Bill & Ed's D1.5 Action items

Bill Powell - Nokia

Figure 142–18—Differential encoding

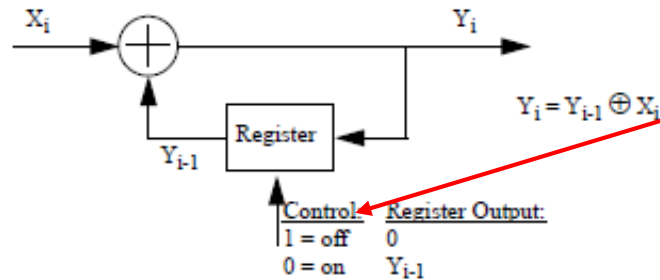
Change Name to DS_Diff_Enc
0 = off
1 = on

- ❑ Proposed changes
 - Map the OLT control bit (DS_Diff_Enc) to Clause 45 - PMA/PMD Control 3 (1.29.15; R/W)
 - Modify Table 45-26a and Fig. 142-18 accordingly
 - Note that only one "lane" needs to be specified as CL45 registers are duplicated for each 25G lane

Change to "Clause 45 register 1.29.15"

Remove Note
